< PL5161 Change Section >

1. RX Part : IF IC change

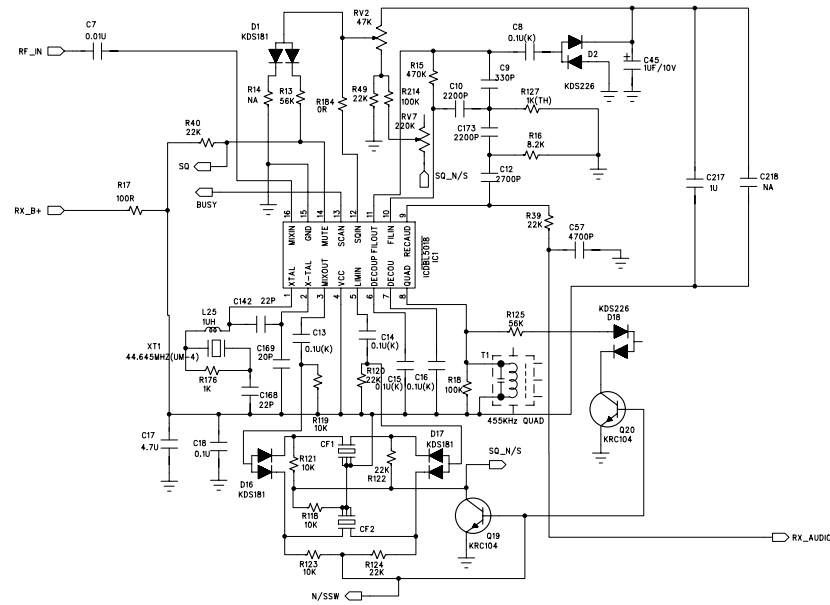
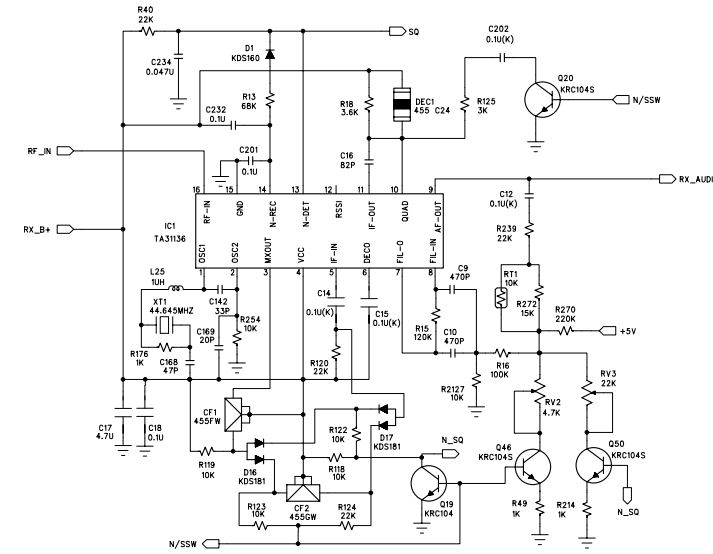
==> Before (DBL5018 / SL5018)

==> After (TA31136)

2. PLL and VCO Part

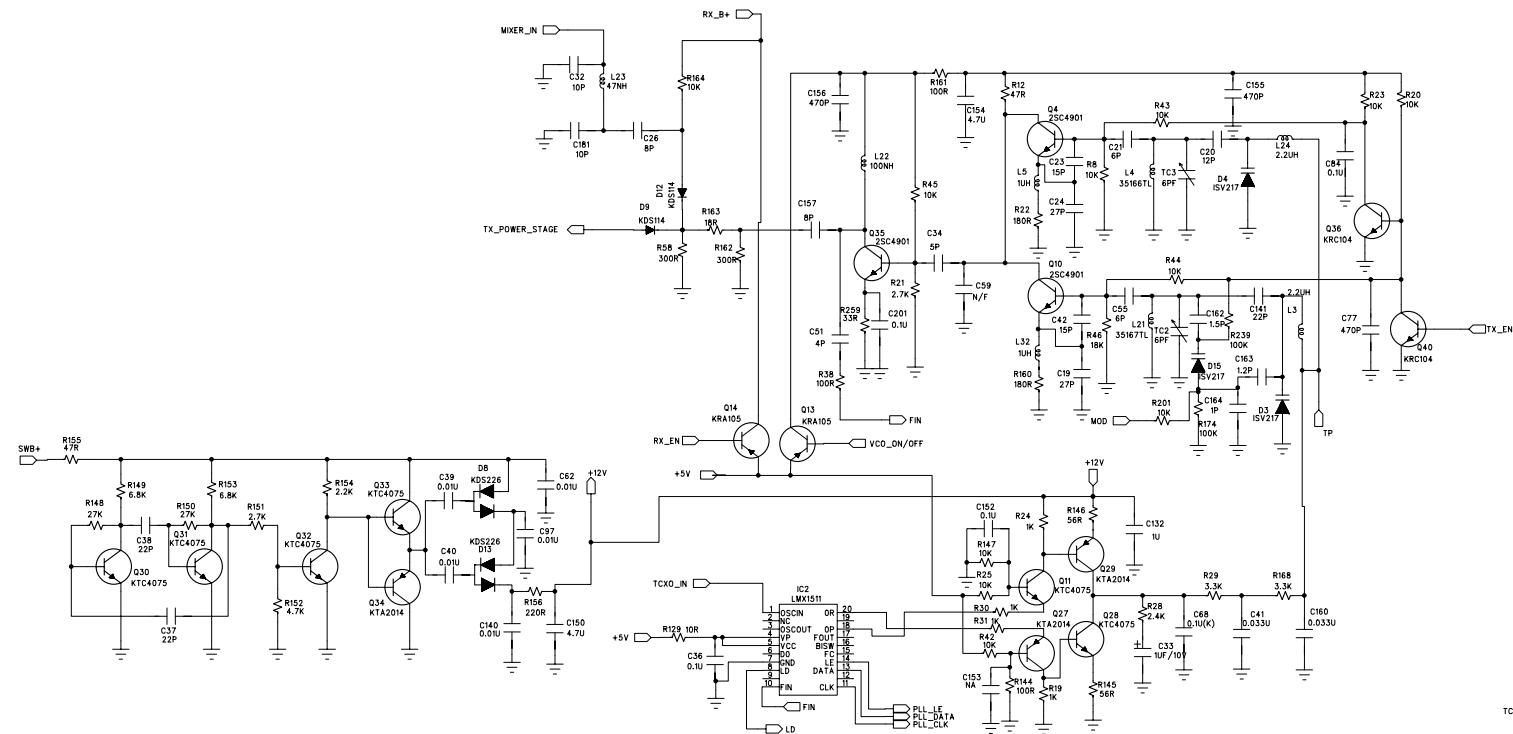
==> Before (PLLIC :LMX1511)

==> After

- . DC to DC Converter :Delete
- . Charge pump : delete
- . PLL IC : LMX2316
- . VCO : Circuit Change
